# **Response to Objection to Outline planning permission for Extension of MIRA Technology Park**

## **Technical Note**

**Document Reference:** EED13833-118-TN-3-1-3

**PROPOSAL:** Outline planning permission for Extension of MIRA Technology Park to comprise employment use (Class B2); associated office and service uses (Class Eg); storage (Class B8); new spine road; car parking, landscaping and enabling works - All matters reserved

Figure 1: Overview of the natural drainage flow routes

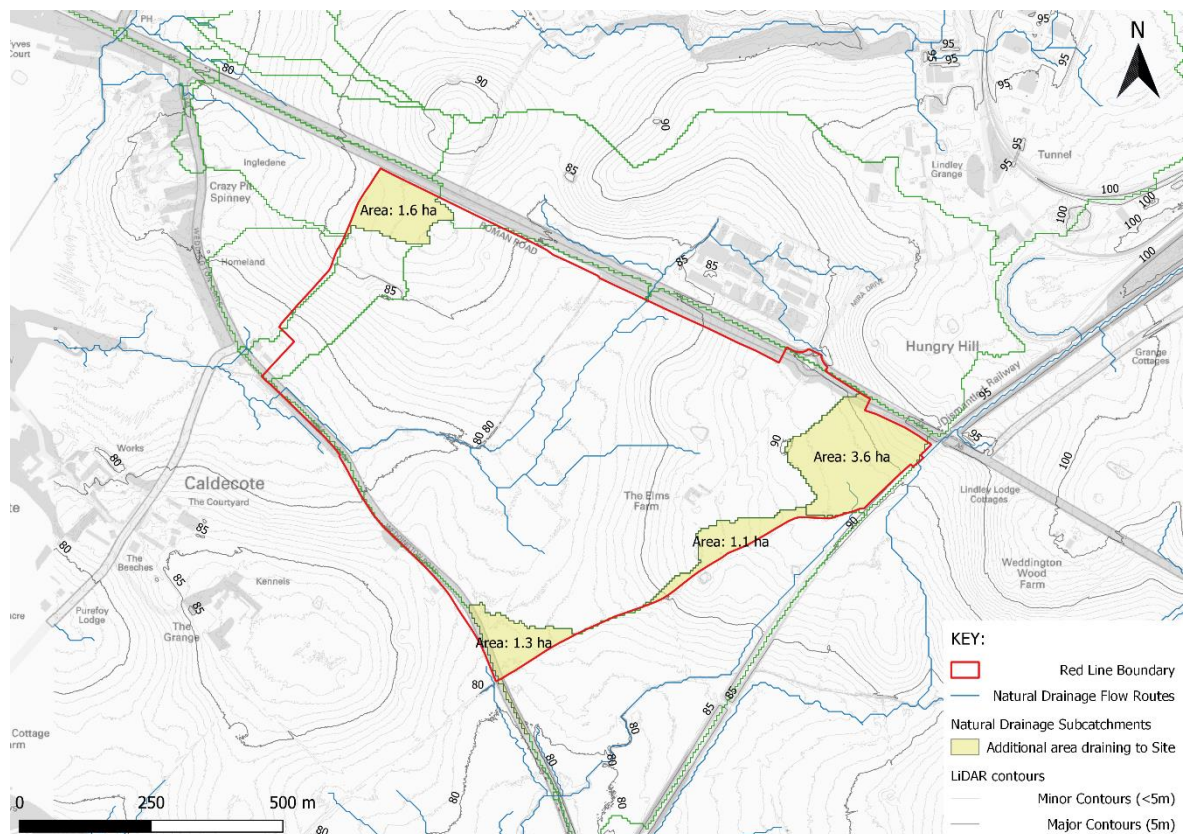
- 2) Given the proposed catchment changes, indicative site levels and further discussion should be provided on the anticipated increase in cross catchment flows and flow routes demonstrating that flood risk will not be increased on site or elsewhere as a result. This should also provide clarification as to whether land raising is proposed as part of the strategy.

2. Given the proposed catchment changes, indicative site levels and further discussion should be provided on the anticipated increase in cross catchment flows and flow routes demonstrating that flood risk will not be increased on site or elsewhere as a result. This should also provide clarification as to whether land raising is proposed as part of the strategy.

- 1.10. All of the runoff from the Site currently drains to the River Anker which is the proposed discharge location of the drainage strategy. Therefore, there will be no increased discharge to the River Anker as a result of the development proposals based on the contributing catchment area.
- 1.11. The change in natural drainage sub-catchments has been assessed and is shown in Figure 1. There is an additional area of 7.6 ha being drained to the on-site watercourse, passing through the culvert at the downstream end of the Site, and eventually discharging to the River Anker.

- 1.12. Although the proposed drainage strategy will increase the area draining to the on-site watercourse, this will all be attenuated to the Greenfield QBAR rate for the existing catchment area so there will be no increase in total runoff from the Site.
- 1.13. It is demonstrated by the previous assessment that the on-site watercourse has sufficient capacity to accommodate the proposed design flow.
- 1.14. As noted in paragraph 3.17 of the FRA (EED13833-118-R-2-4-3-FRA), the LLFA have previously raised concerns regarding historical flooding in the area of Weddington to the east of the Site. The eastern sub-catchments of the Site within the existing Weddington catchment area will be actively drained as part of the proposed drainage strategy. Therefore, flows will be transferred from the

Weddington, known to be at risk of flooding, to the on-site drainage network and watercourse, which has been confirmed to have sufficient capacity to accommodate the additional flows.

- 1.15. Land in the northern corner the Site that currently drains to the catchment to the west will also drain to the on-site drainage network and watercourse, both of which have sufficient capacity to accommodate the additional flows.

**Topographical Survey**

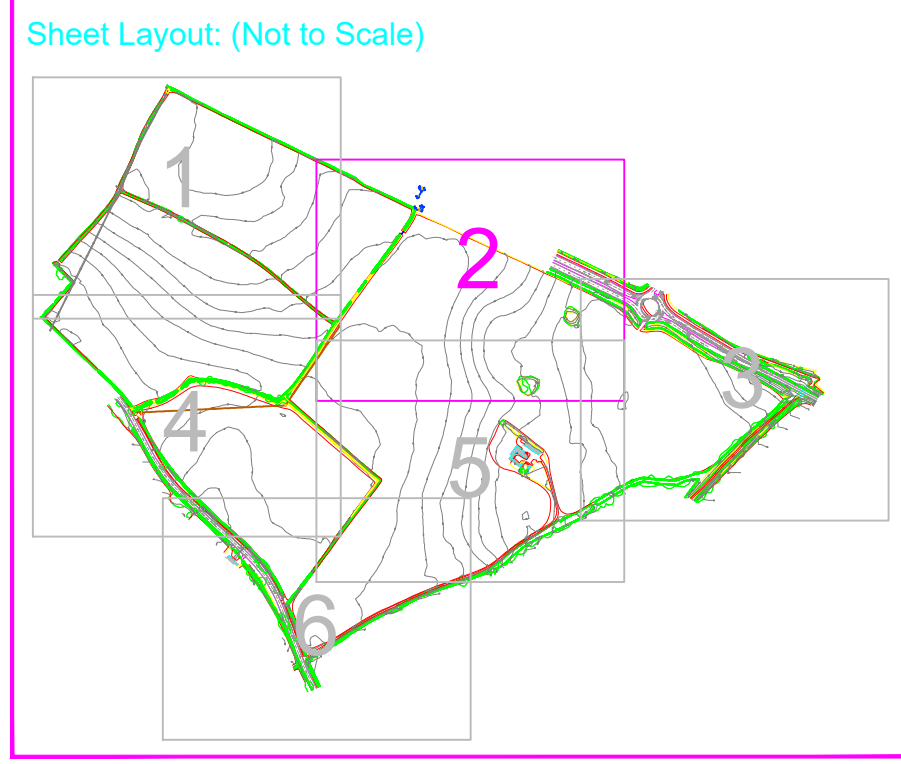
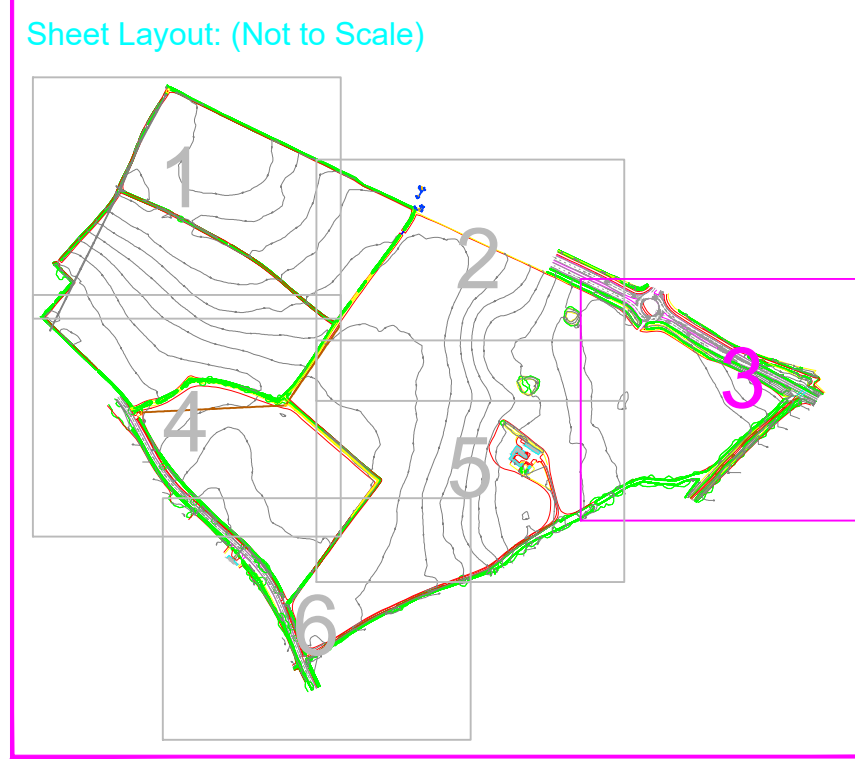
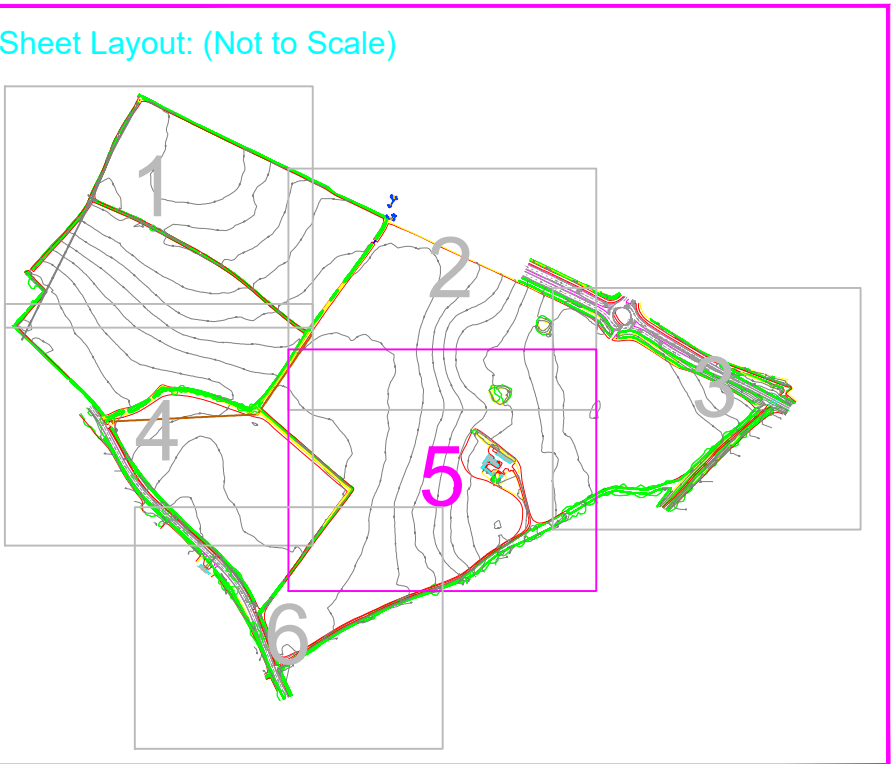
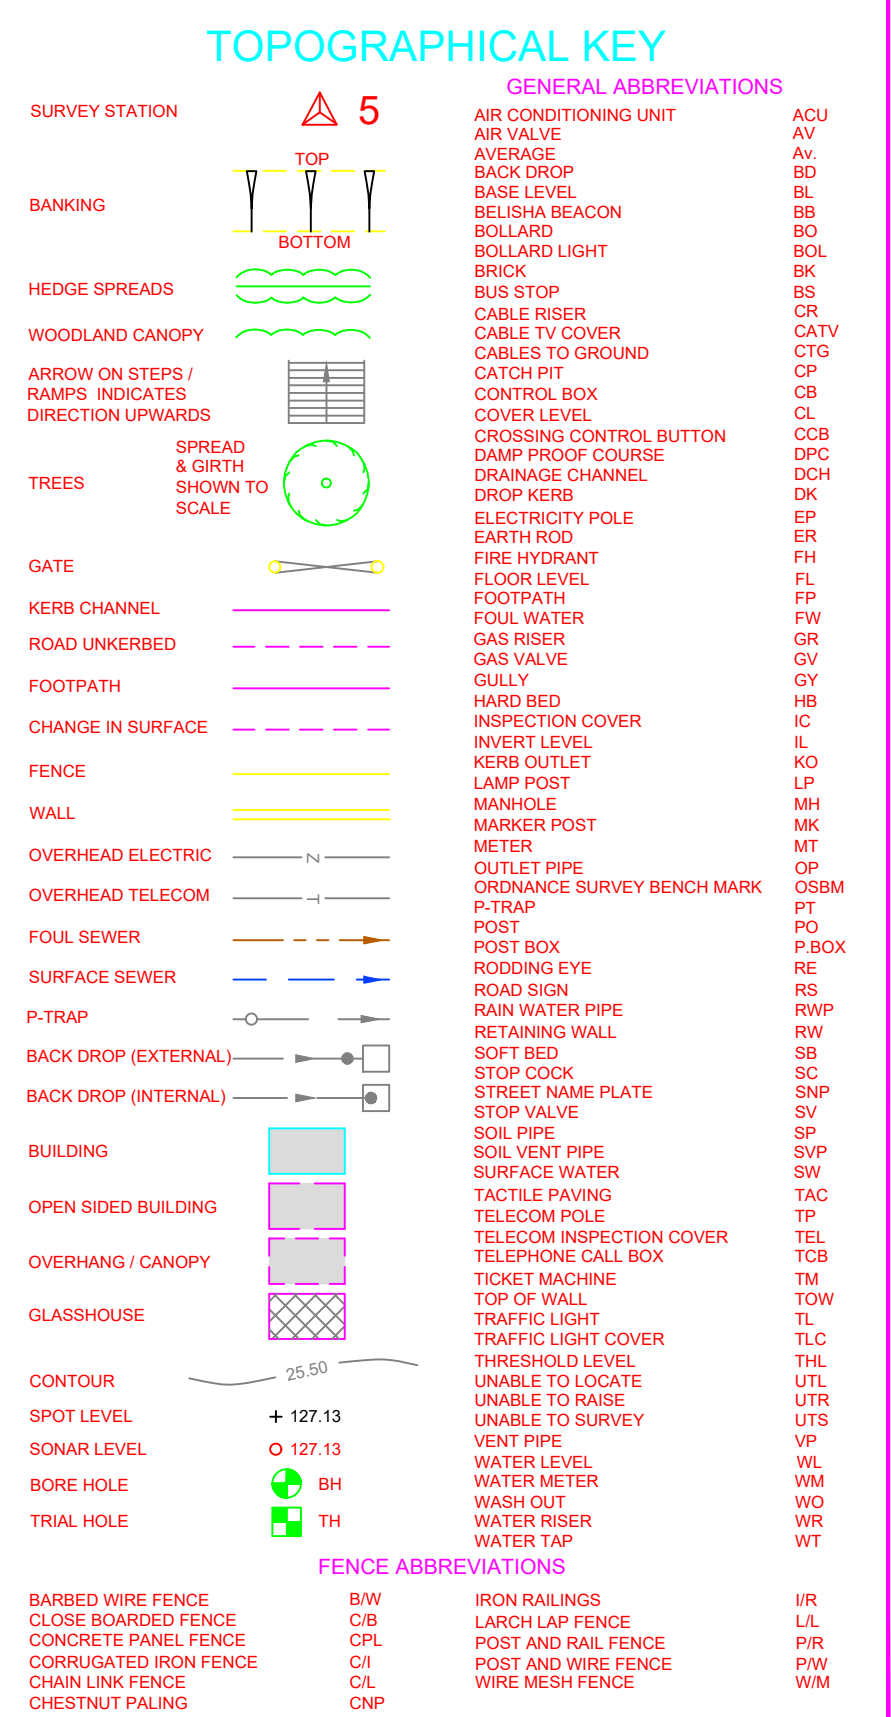
- An evaluation of the on-site channel capacity including surveyed cross sections demonstrating that there is sufficient capacity to accommodate contributing flows from the site. This is particularly pertinent given the proposals to remove storage capacity on site by infilling the southern ditch and increase the contributing catchment area to the watercourse.

- An evaluation of the on site channel capacity including surveyed cross sections demonstrating that there is sufficient capacity to accommodate contributing flows from the site. This is particularly pertinent given the proposals to remove storage capacity on site by infilling the southern ditch and increase the contributing catchment area to the watercourse.

- 1.3. The channel capacity of the on-site watercourse has been assessed using topographic survey information (Appendix B) and Manning's Equation for open-channel flow (calculation details provided in Appendix C).

- 1.6. The minimum capacity of the channel is 2.38 m<sup>3</sup>/s at the upper end of the watercourse.
- 1.7. Therefore, there is sufficient capacity within the channel to convey the maximum design flow (1.90 m<sup>3</sup>/s), allowing for both the upstream contribution (1.66 m<sup>3</sup>/s) and the proposed discharge from the Site (0.24 m<sup>3</sup>/s).
